## **Access Compliance Report Public Rights-of-Way** (Curb Ramps)

Intersection ID: 10028296 Main Street: HENSEY'S WY Cross Street: N/A Location: W Initial Pass/Fail: Fail **Overall Compliance: No Severity Score:** 12.5 ADA ID: 86EE095F2117 Ramp Type: Perp

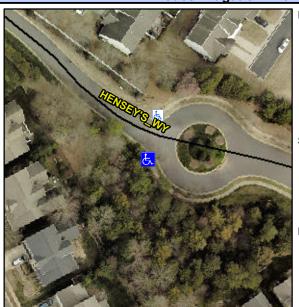
**HENSEY'S WY** Street 1 Name Stop Condition-Street 2 None N/A Street 2 Name Stop Condition-Street 1 N/A Possible Solutions: Remove & Replace Entire Ramp. Surveyor Notes: N/A PROW/ADA: R304.2.2
